## Product Change Notification / ASER-11ZWRV458

CCB 5295 Initial Notice: Qualification of MTAI as a new final test site for selected AT17LVxxx device family available in 8L PDIP (.300in) package.

## Pre and Post Change Summary

### PCN# ASER-11ZWRV458

# Tube Comparison – BQM and Pin 1 Orientation

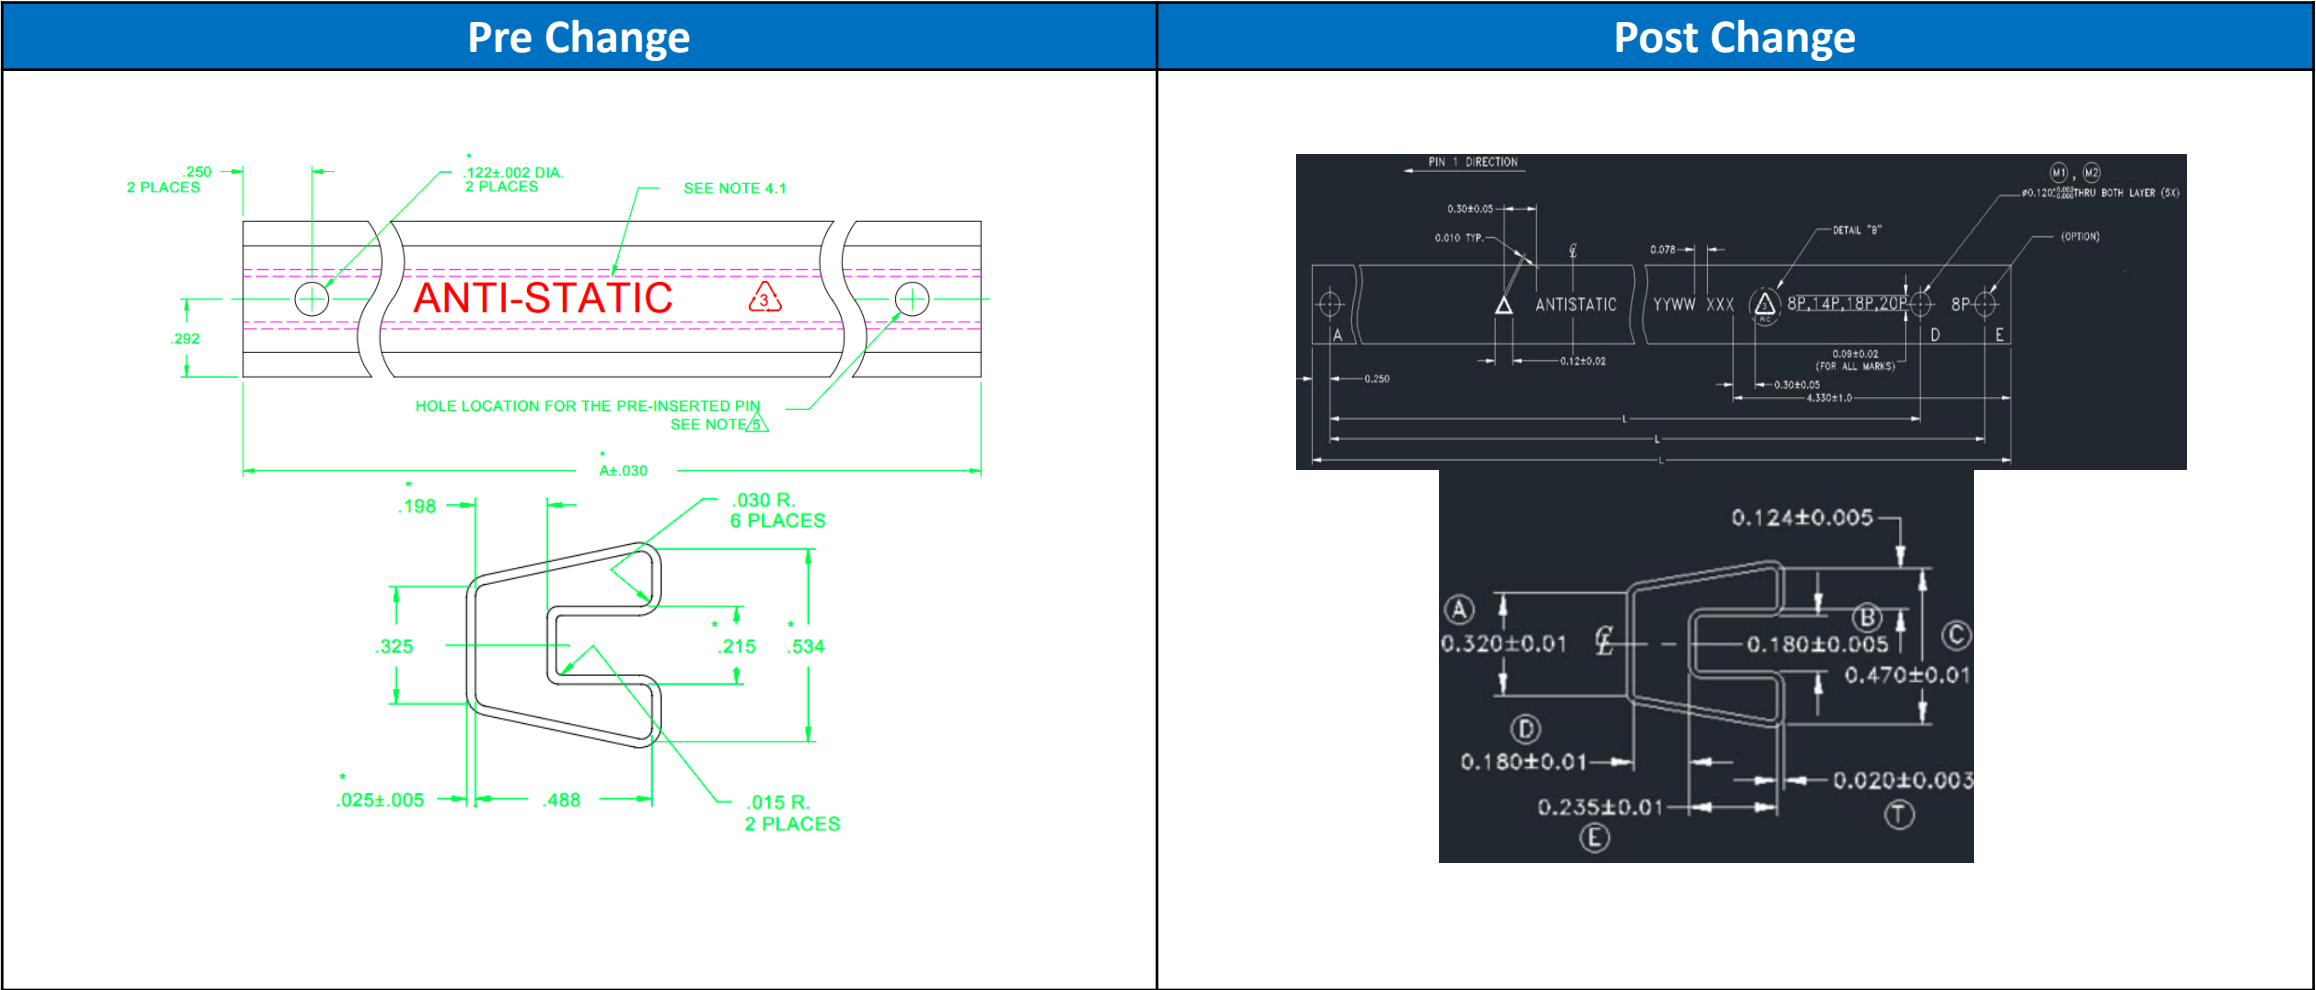
Philippines (P3/P4), INC. (ATP7)	Technology Thailand (MTAI)
Pin 1 Orientation	Towards White Pin	Towards White Pin
BQM	50	50
Tube per Bag	50	40
Pin Color	Black/White	Black/White
Tube Drawing	Minor dimensional changes. See Pre and Post Change Summary attachment for comparison.	
Packing Method	See Pre and Post Change Summary attachment for comparison.
